# MARCO POLO - 101 W 33RD STREET

Date	Description
05.19.2022	Progress Set

4B A001 LIFE SAFETY - 1ST FLOOR  
1/16" = 1'-0"

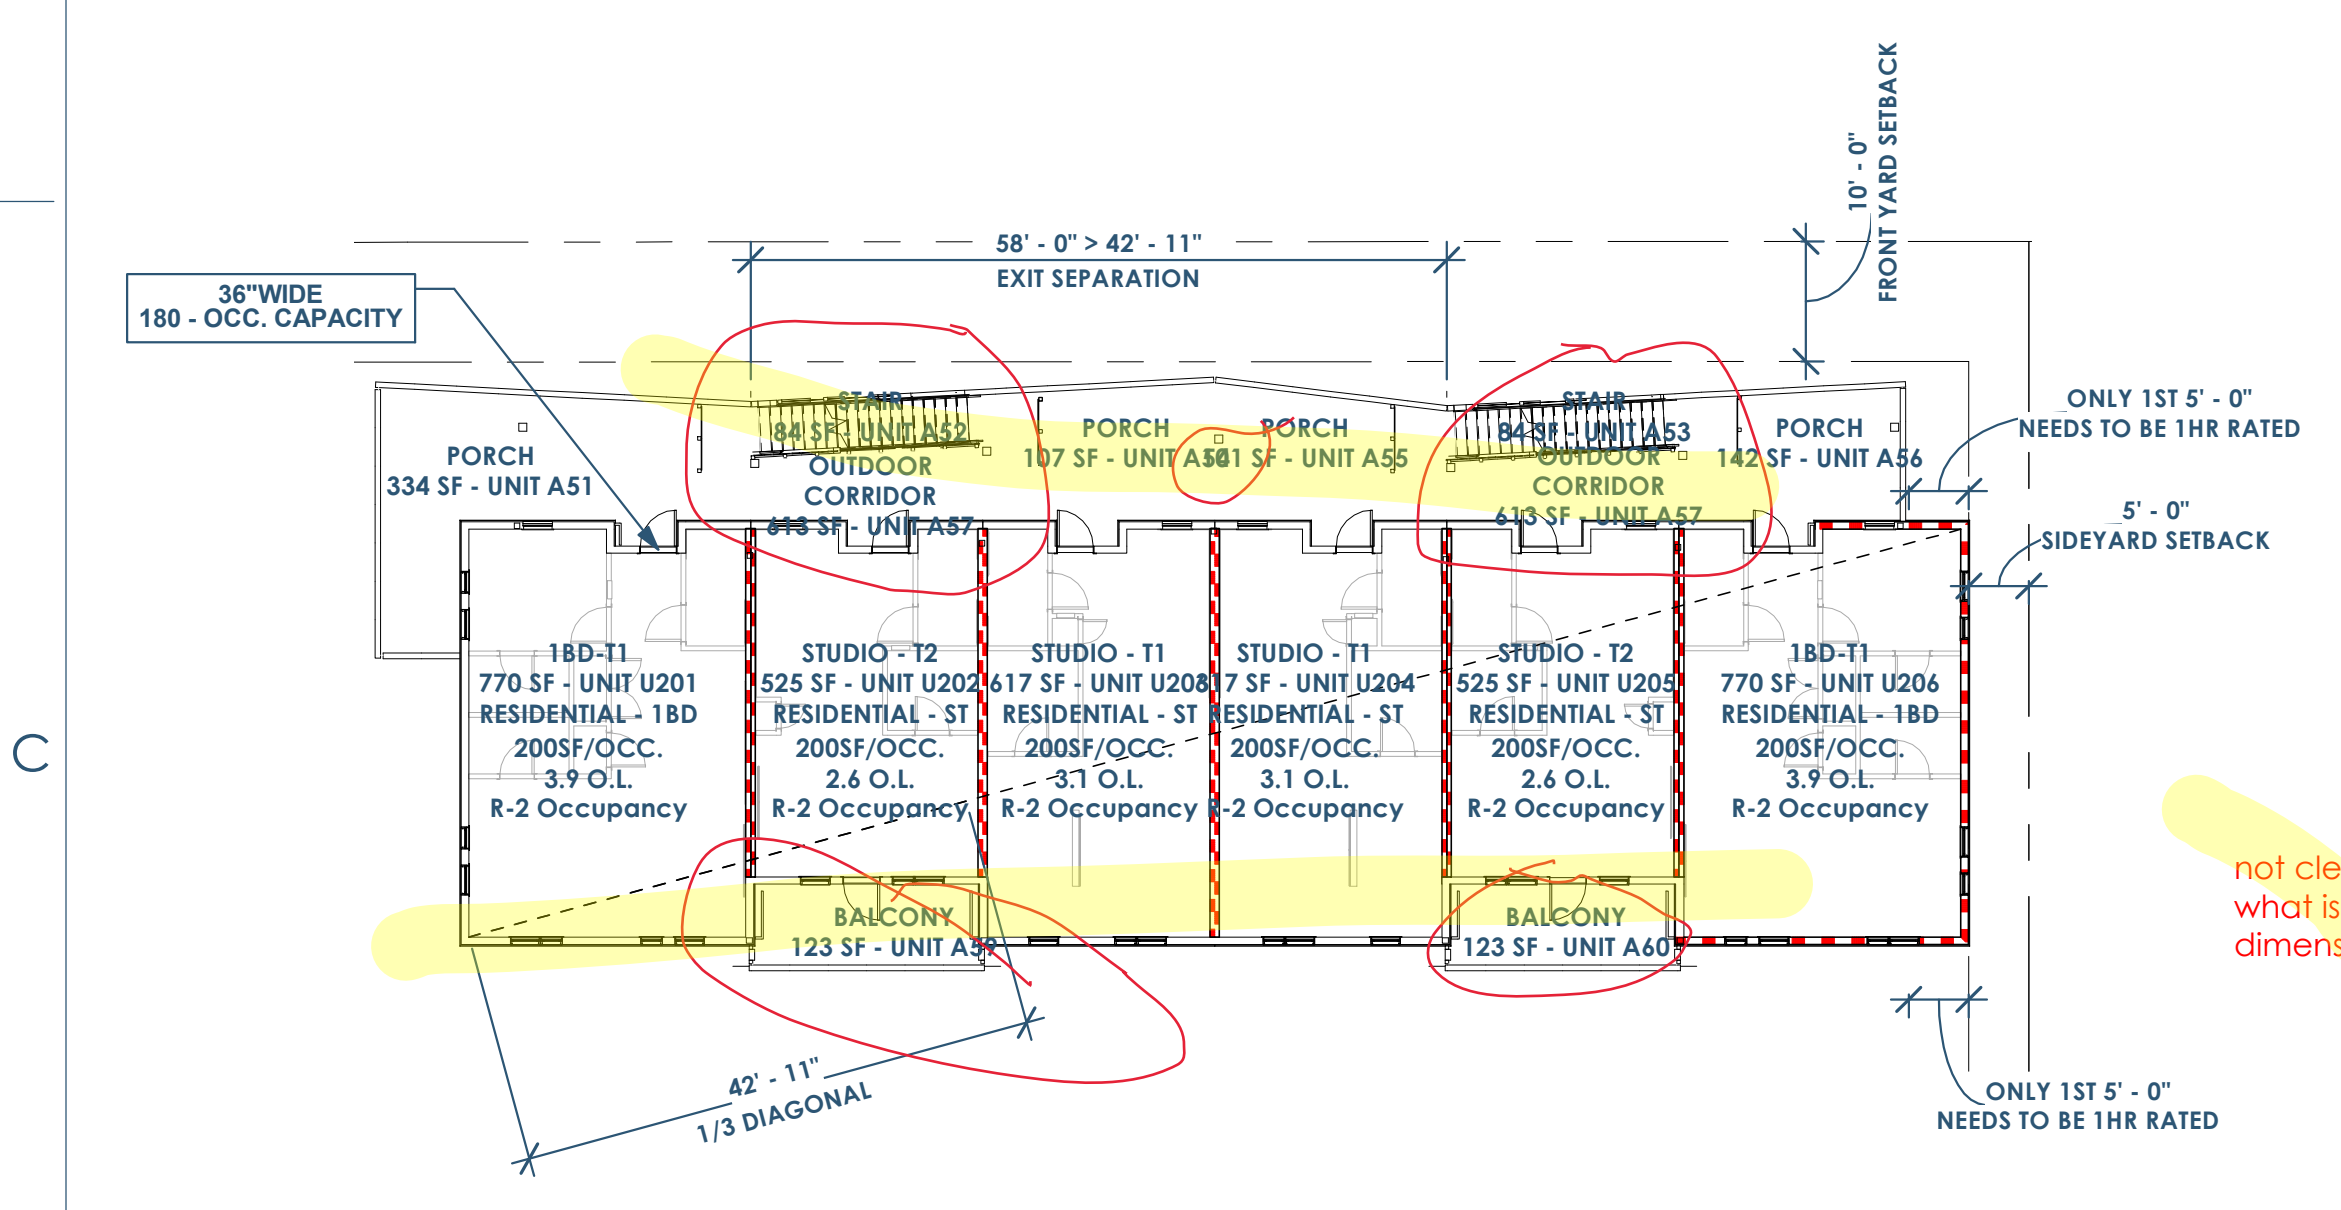
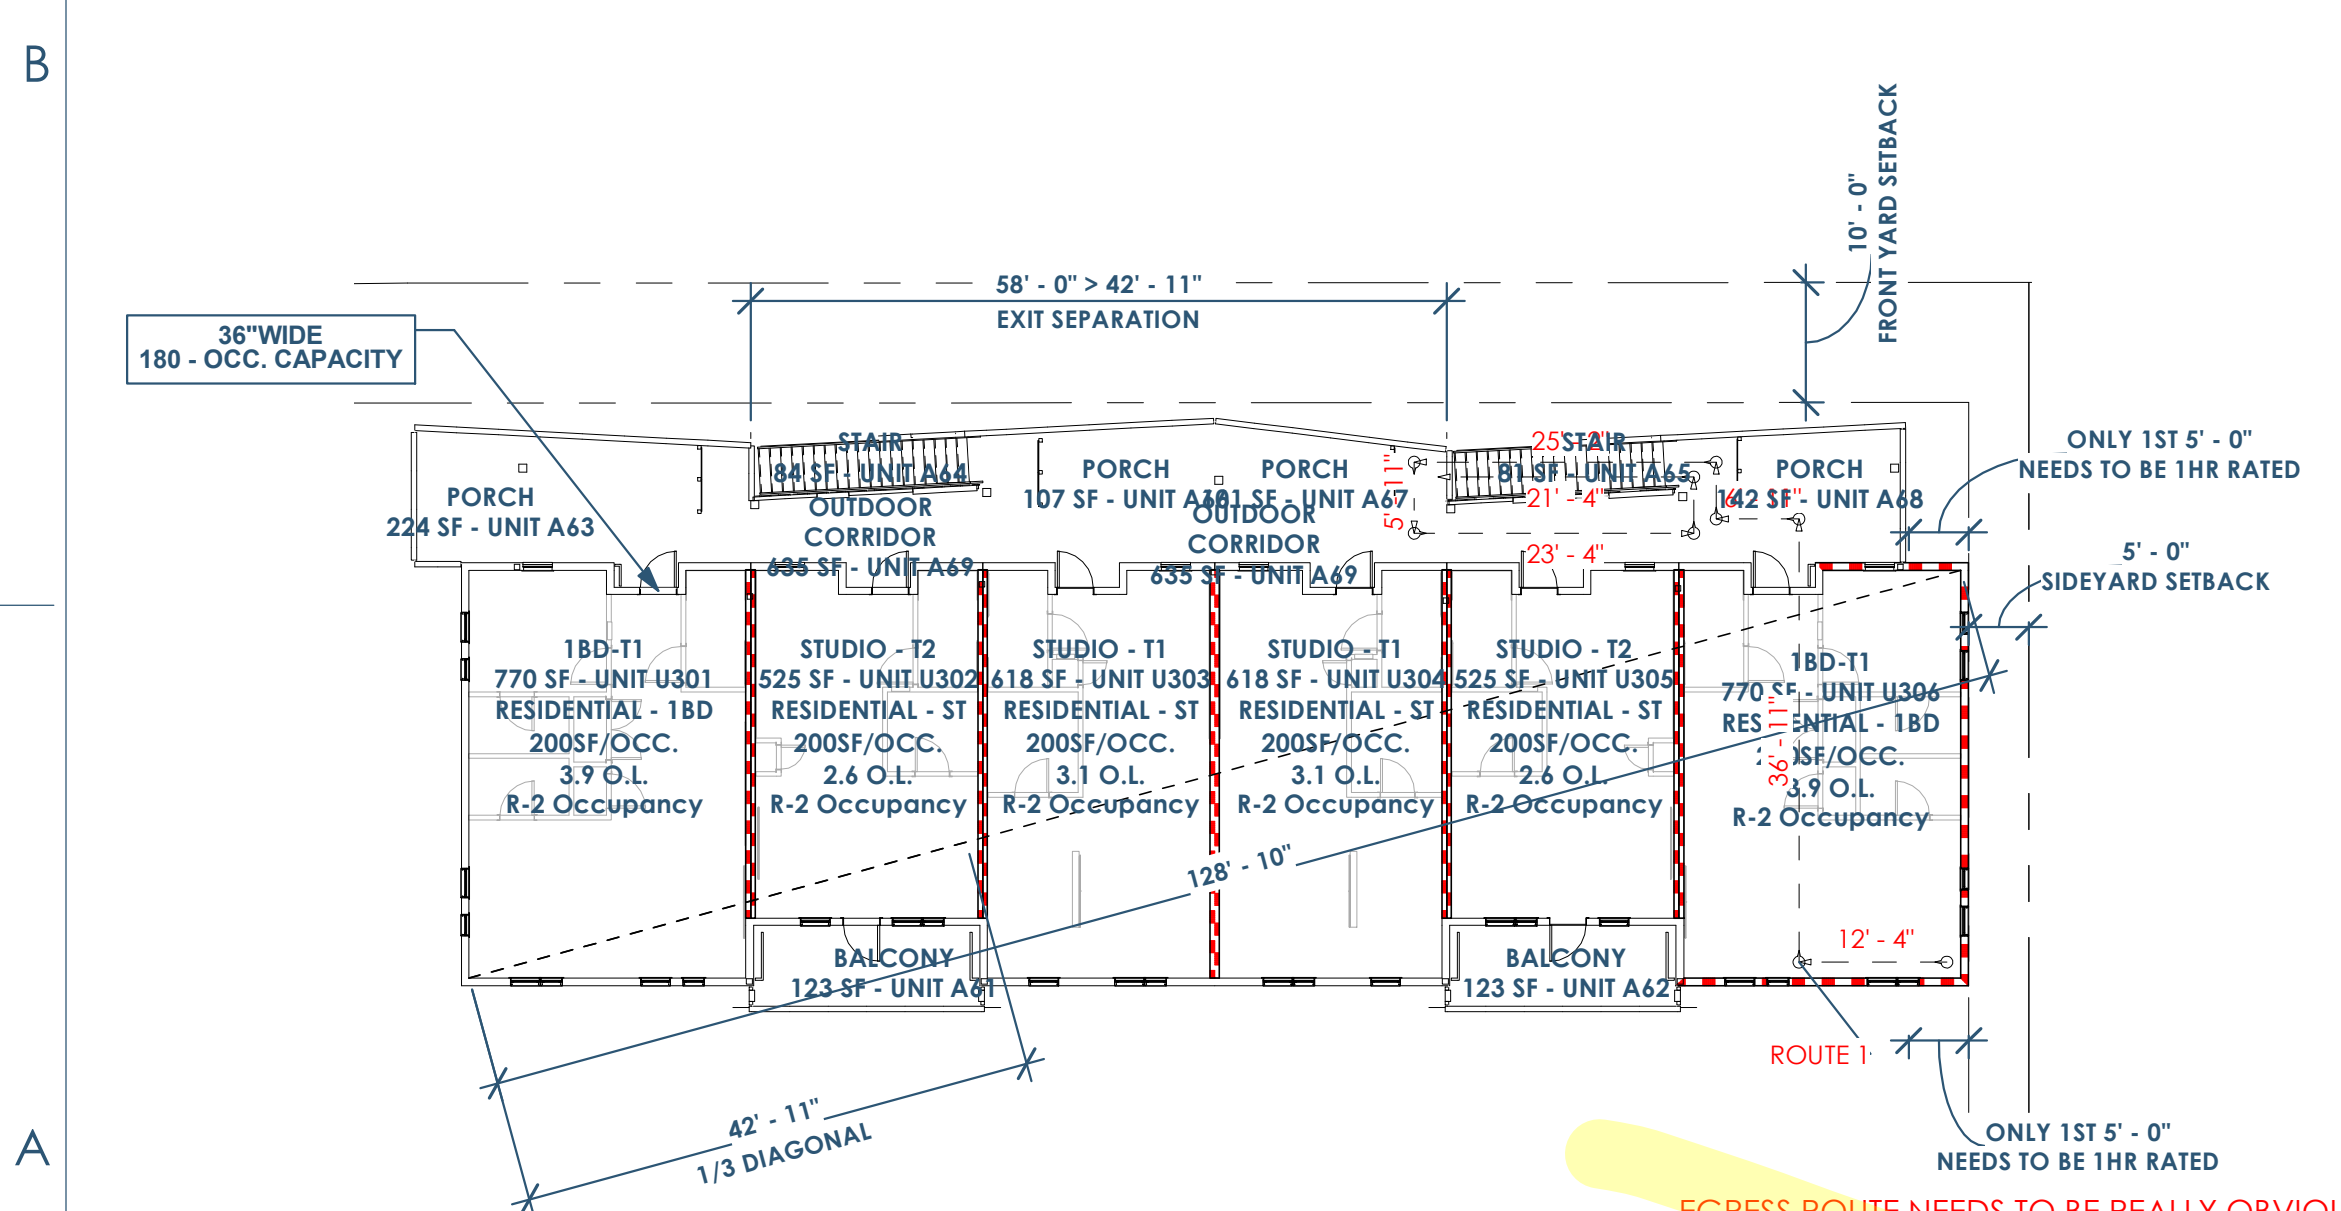
EGRESS ROUTE NEEDS TO BE REALLY OBVIOUS - RIGHT NOW IT GETS LOST UNDER ALL THE TEXT. MAYBE MAKE THE BLACK DASHED LINE HEAVIER AND MAKE IT A SEPARATE DIAGRAM WITHOUT ALL THE OTHER TEXT AND NOTES ON THE SAME PLAN. IF THE CITY HAS TO TAKE MORE THAN 2 SECONDS TO FIGURE SOMETHING OUT THEY WILL LABEL IT AS MISSING AND KICK IT BACK TO US, WHICH WILL COST MORE TIME.

1 FLOOR PLAN - 1ST FLOOR  
1/4" = 1'-0"

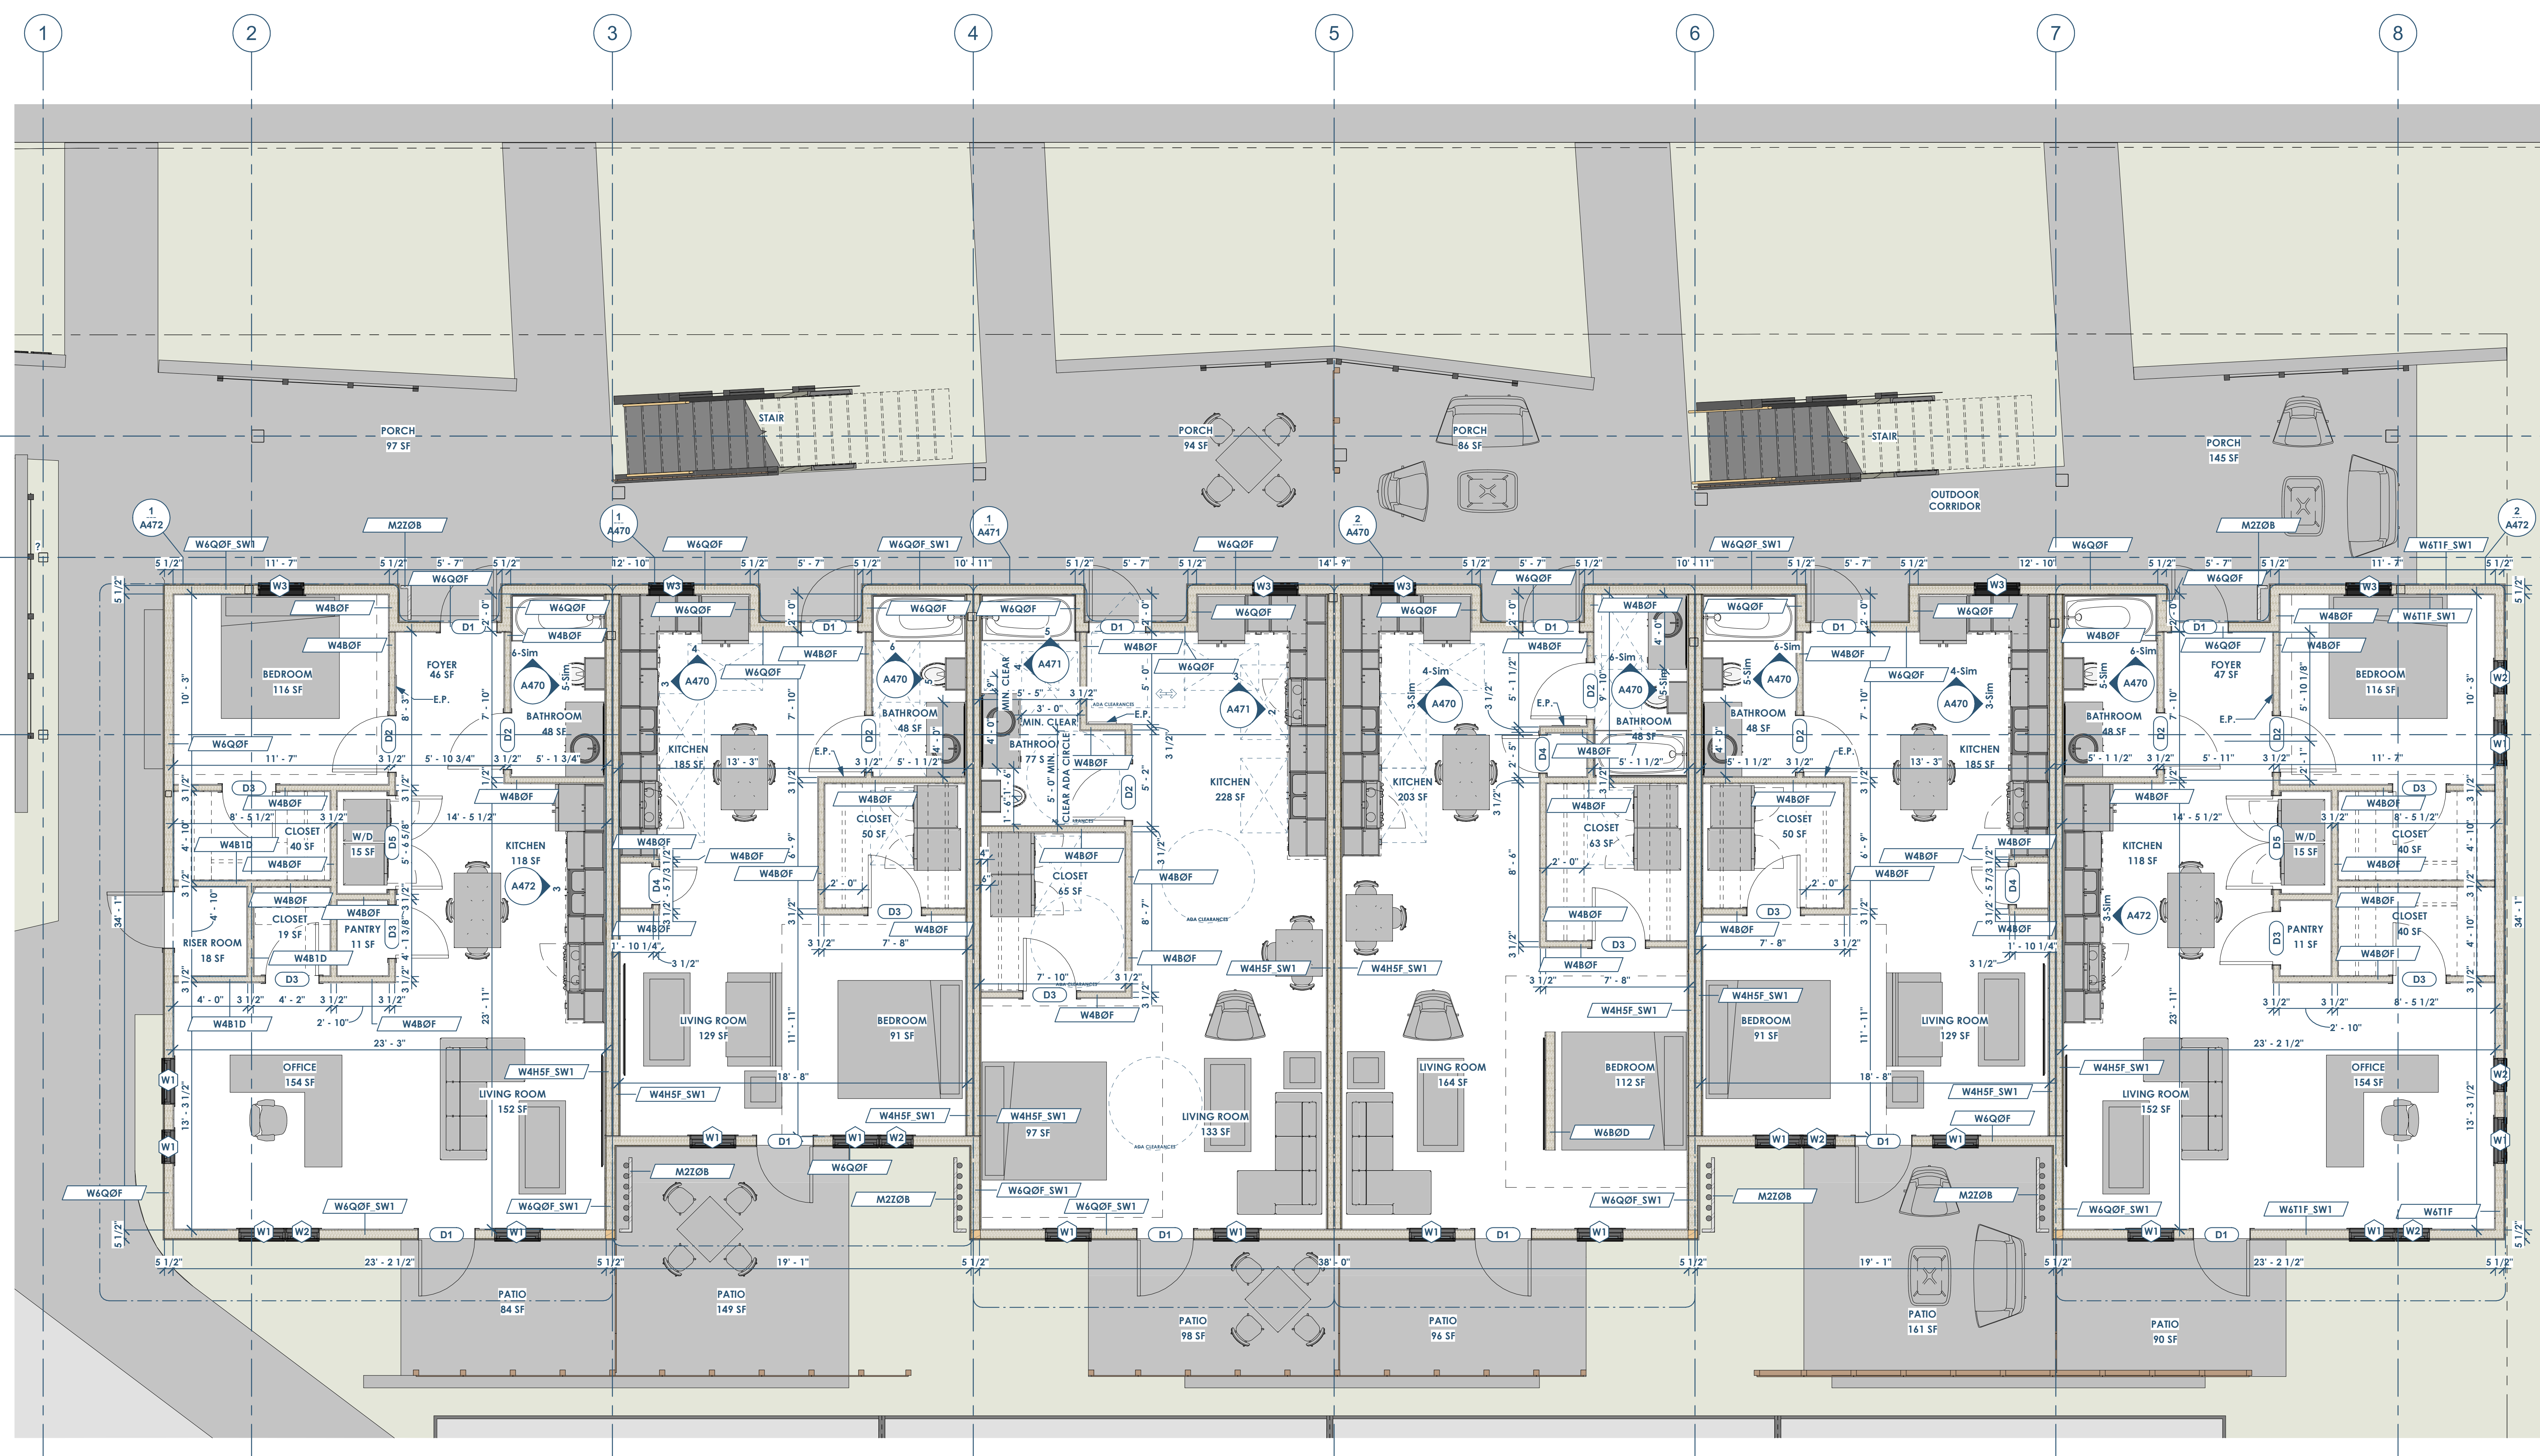
- 1. REMOVE FURNITURE FROM THIS PLAN
- 2. DIMENSION GRID LINES AND TIE EXTERIOR WALLS TO GRID LINES. CONVENTION WITH WOOD FRAMING IS TYP. TO ONE SIDE OF WALL OR THE OTHER, TO CENTER LINE OF WINDOWS AND DOORS, NOT TYP. TO DIMENSION STUD THICKNESSES B/C INFO IS ALREADY CALLED OUT IN PARTITION TYPE TAG AND WALL SECTIONS.

- 3. OVERALL BUILDING DIMENSIONS ARE MISSING. SINCE ENLARGED PLANS SHOW DETAILED INTERIOR INFORMATION FOR THE UNITS, IT SHOULDN'T BE DUPLICATED HERE. THESE PLANS SHOULD FOCUS MORE ON THE OVERALL FLOOR PLAN INFORMATION.

- 4. REFERENCE HOW THE SPACE PLAN UNIT LAYOUTS ARE SHOWN ON THE PERMIT DRAWINGS FOR THEIR PREVIOUS PROJECT. LESS IS MORE WHEN IT COMES TO THE CITY. THERE CAN ALWAYS BE ANOTHER SHEET WITH FURNITURE AND MORE LABELED SPACES FOR ANY DRAWINGS THE RW USE FOR MARKETING.

- IF THE PLAN REVIEWER HAS TO TAKE MORE THAN A FEW SECONDS TO FIND WHAT THEY ARE LOOKING FOR, THEY WILL LABEL IT AS MISSING AND KICK IT BACK TO US. ALSO, IF THEY SEE SOMETHING LABELED A BEDROOM WHEN WE ARE CALLING IT THE UNIT A STUDIO, THEY MIGHT ANALYZE IT DIFFERENTLY AND COME UP WITH ADDITIONAL RULES THAT APPLY.

- 5. ADD GENERAL NOTE TO REFERENCE SHEET A800 FOR PARTITION TYPES.
- 6. ADD EXTERIOR ELEVATION TAGS AND BUILDING SECTION CUTS.
